Addendum 02

DOCUMENT 00 91 00

DATE: January 29, 2026

PROJECT: Tipp City Seniors New Addition
528 North Hyatt Street
Tipp City, Ohio 45371

3 BUILDING SECTION - PARTIAL
1/4" = 1'-0"

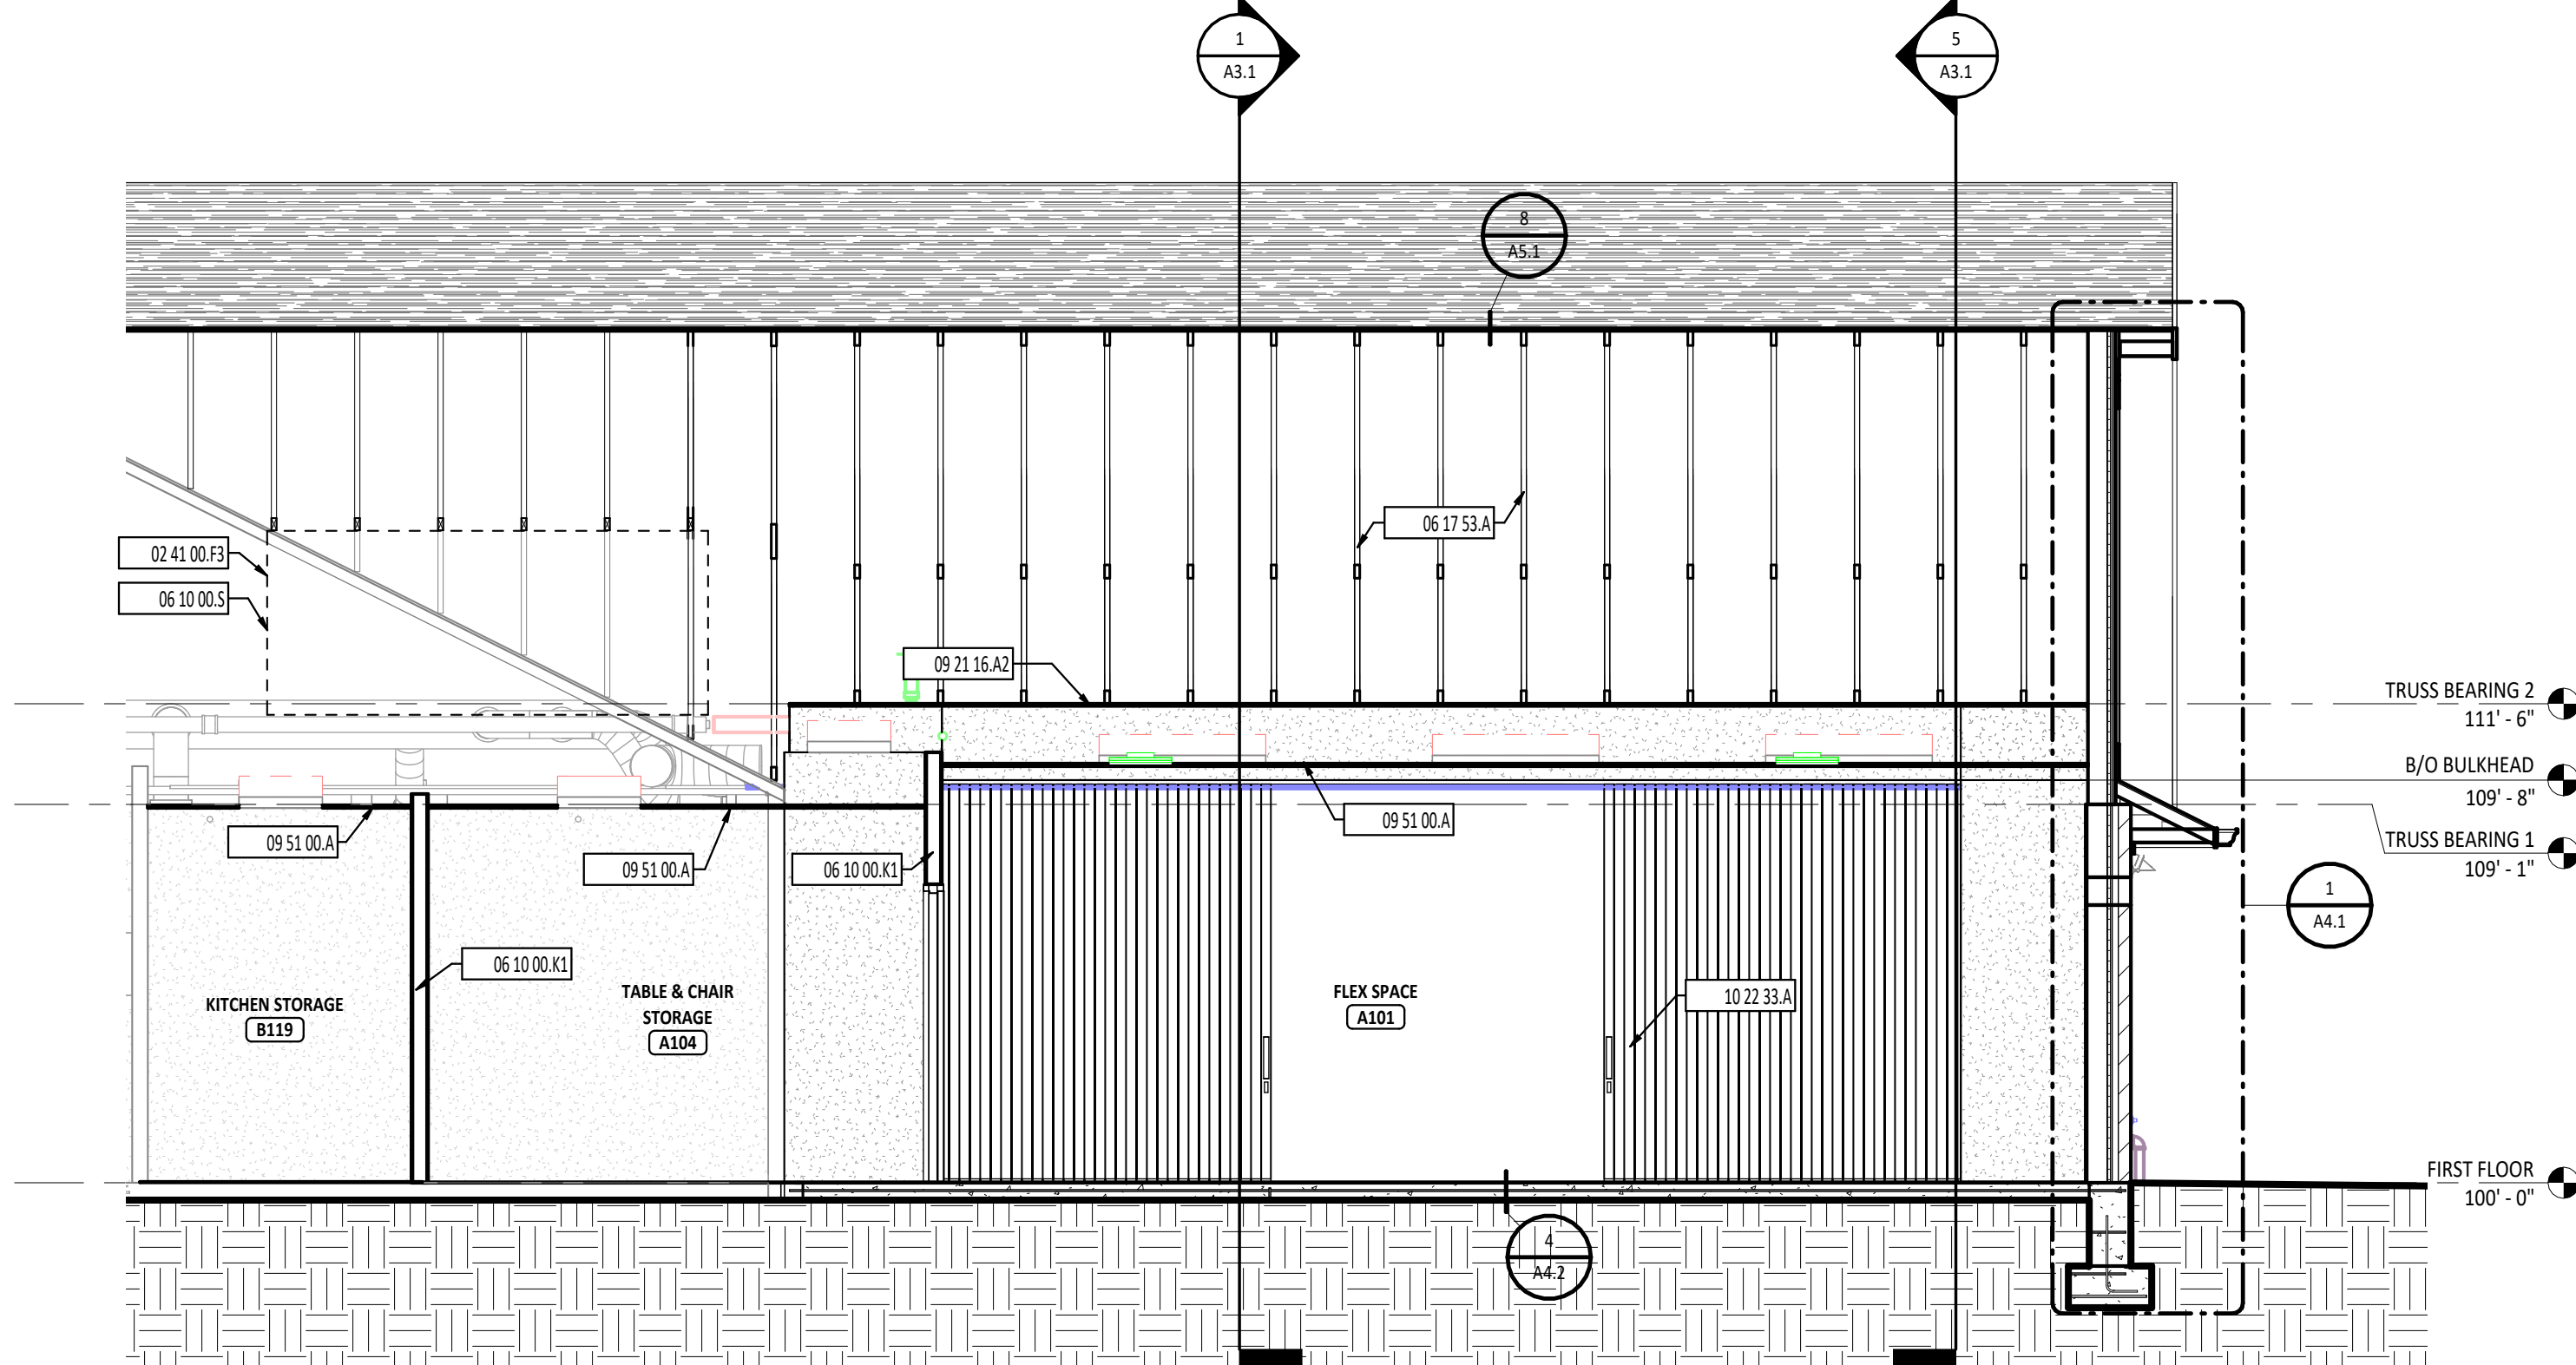
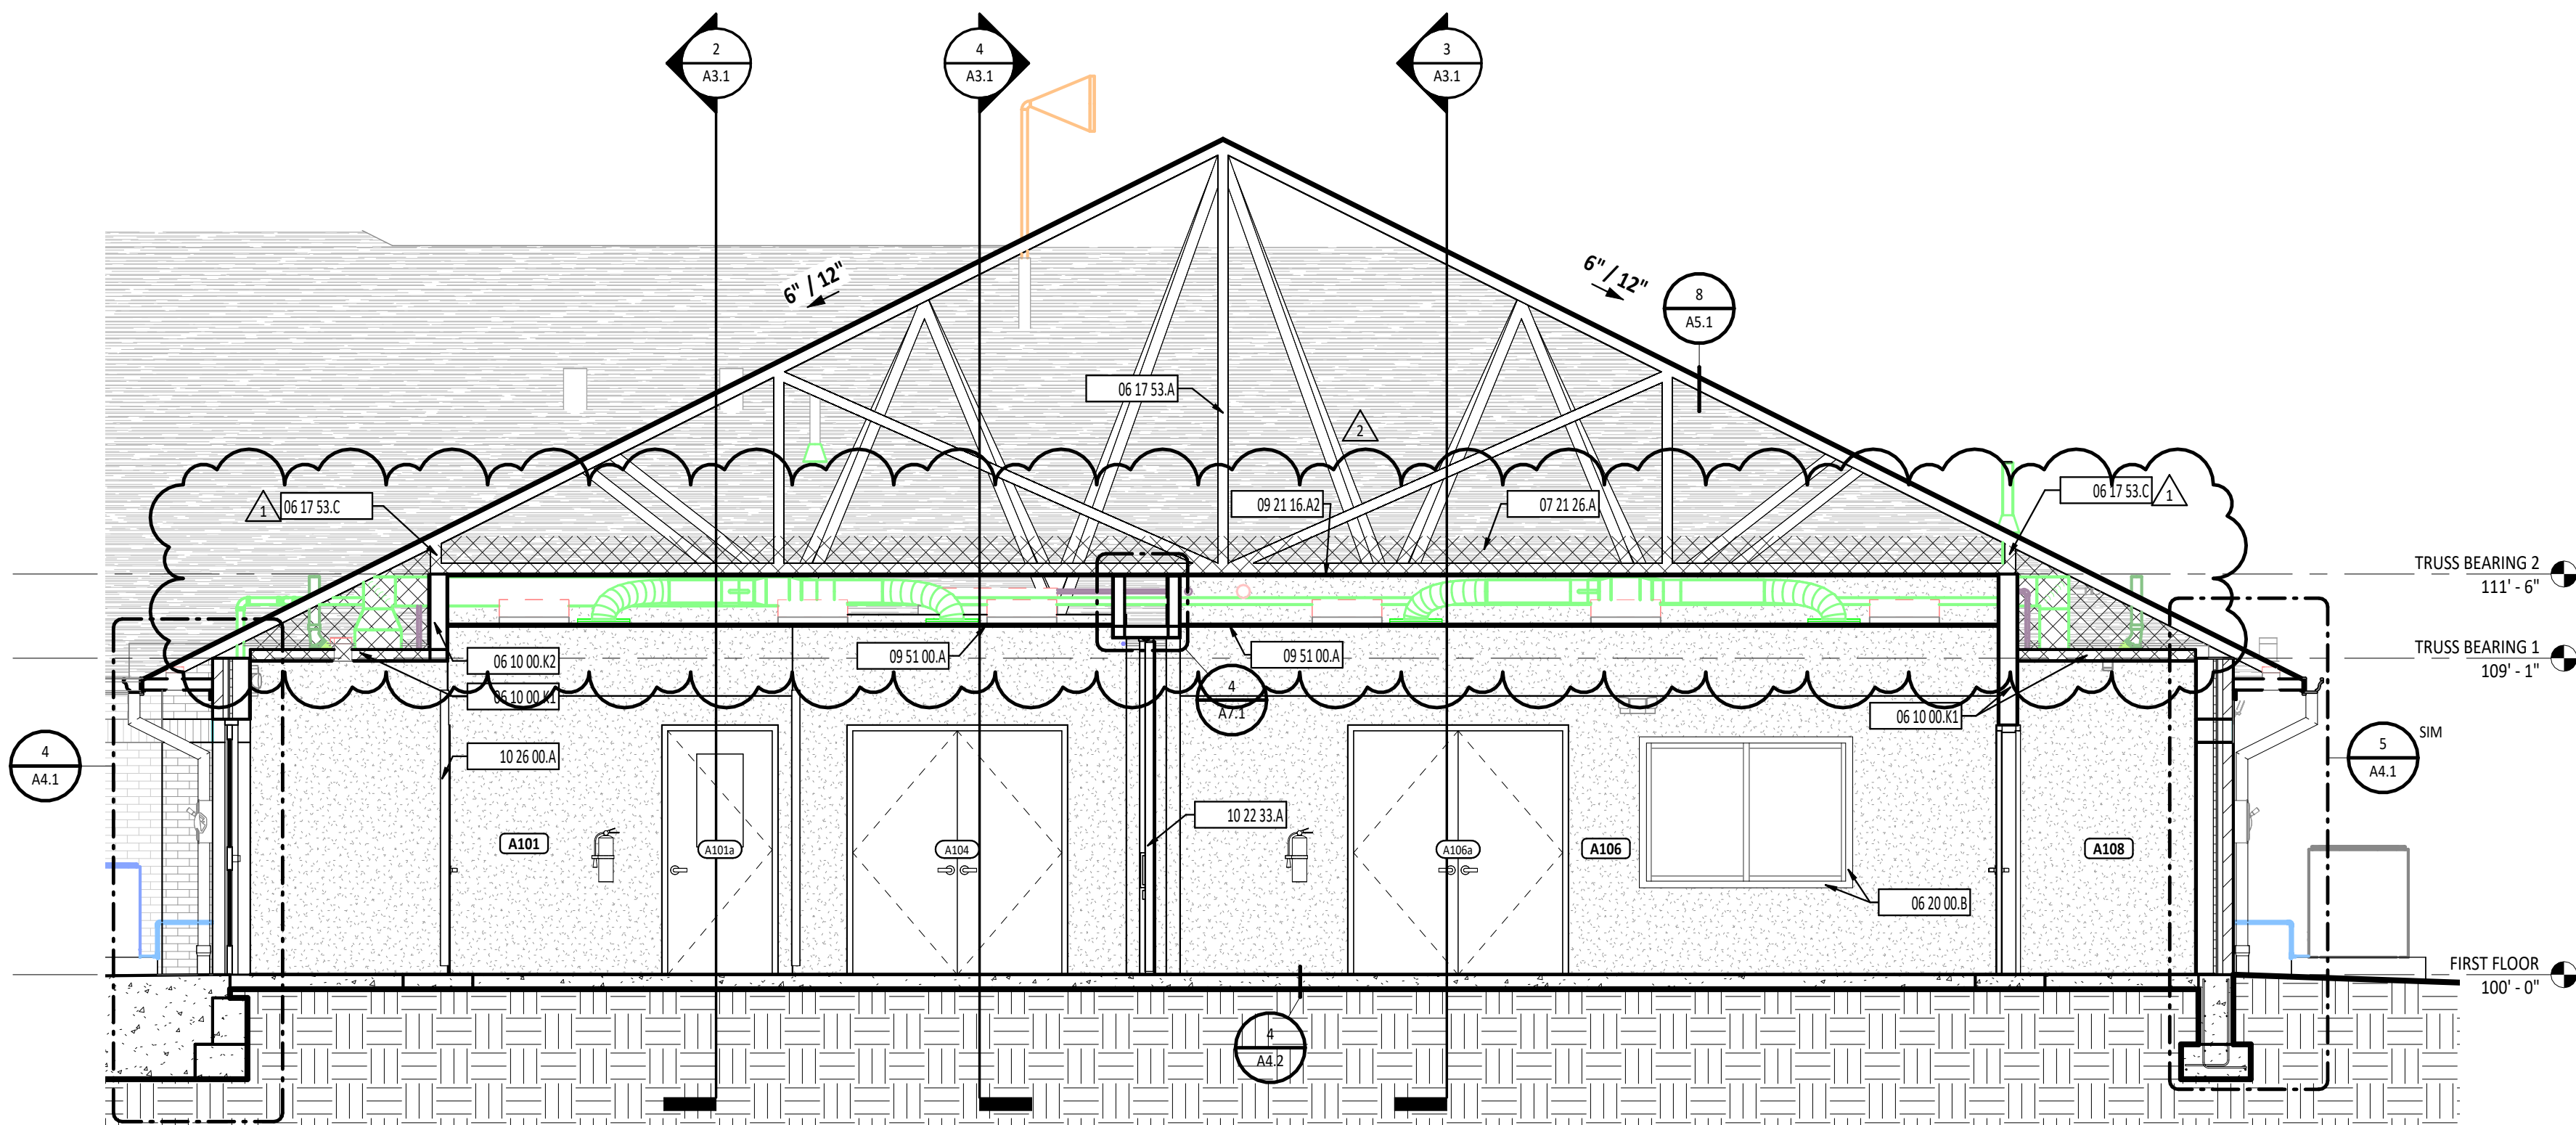
1. Drawing Sheet A3.1 Building Sections:
 - a. Added blown insulation in concealed areas where required.
2. Drawing Sheet A4.1 Wall Sections:
 - a. Added additional blown insulation to detail 5/A4.1.

9 EAVE DETAIL WITH SOFFIT
A5.1 1 1/2" = 1'-0"

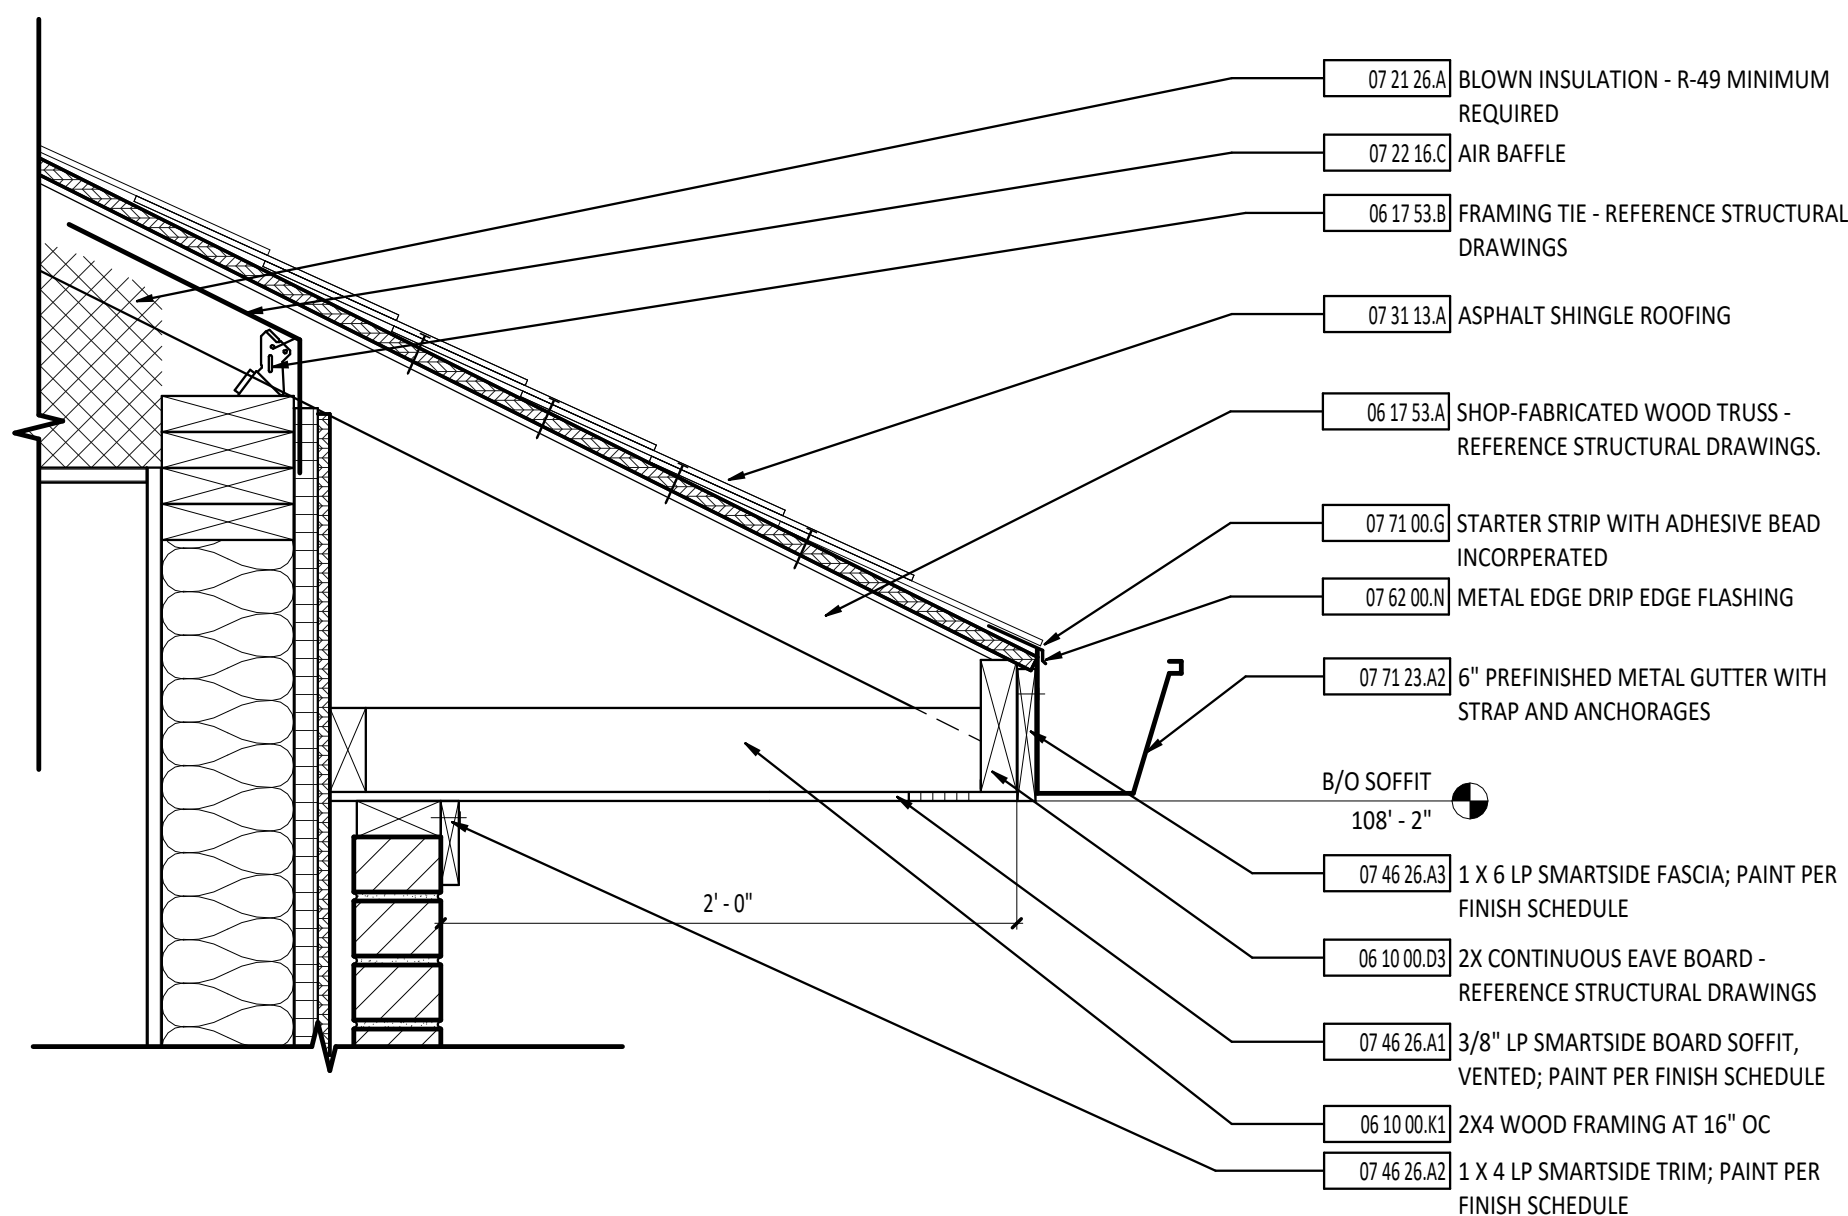
3. Drawing Sheet A5.1 Roof Plan and Roof Details:
 - a. Added flue penetration and vent penetration details
 - b. Added keynotes to the roof plan for new and existing flue and vent penetrations
